SERVICE BULLETIN

NUMBER: 15-211-17R

REVISED: 12/05/18

SUBJECT: Reprogramming File Availability for Additional Optimization of Harman Gen 3 Audio and Navigation Head Units

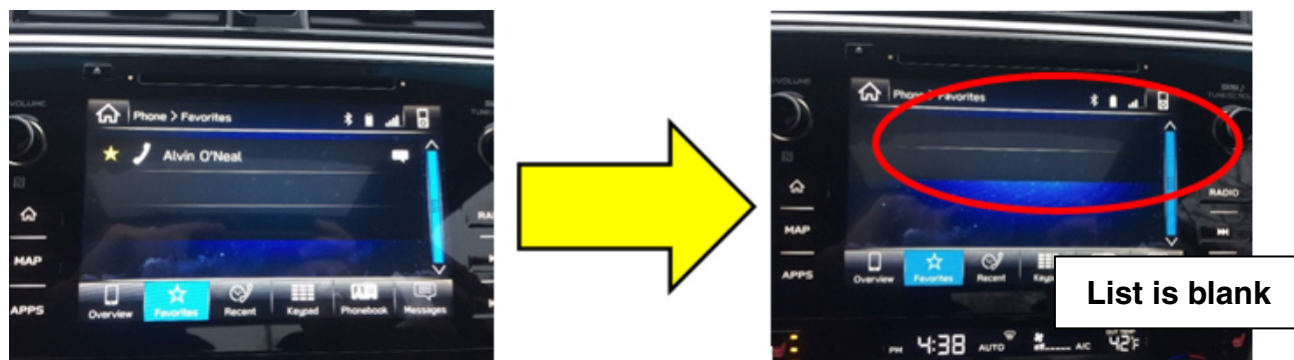
- On 2018MY Legacy / Outback models with Navigation (High) head units, the update corrects a condition where the head unit remains powered even after the ignition is OFF and the driver door is opened.
- Corrects for a condition where the SXM presets become lost and only “Initializing” appears as shown below.

- Corrects for condition where only the star field background is displayed (without icons) after the HOME button is pressed.

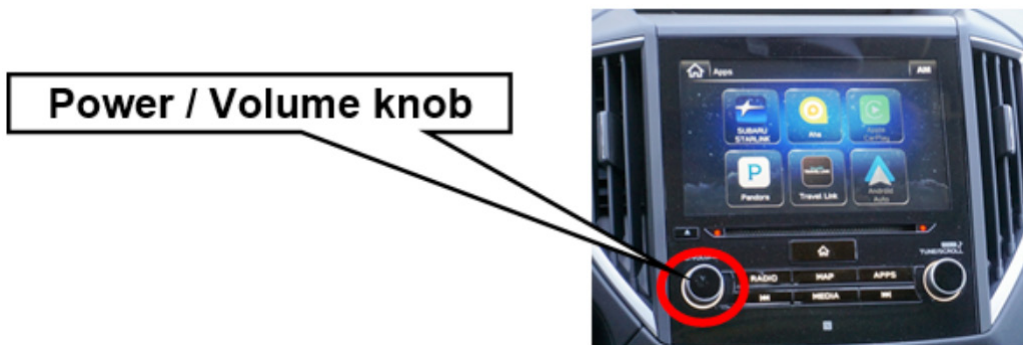
- Operation of the head unit after switching the ignition off and back on has been revised:

PREVIOUS Version: The head unit power is turned OFF by pressing the Power/Volume knob for 4 or more seconds. On the next ignition ON, the display remains OFF / black while the audio begins playing automatically. This was the prior characteristic operation.

NEW Version: The head unit power is turned OFF by pressing the Power/Volume knob for 4 or more seconds. On the next ignition ON, the display remains OFF / black and the audio will also be OFF until the Power/Volume knob is pressed to turn the head unit back ON.
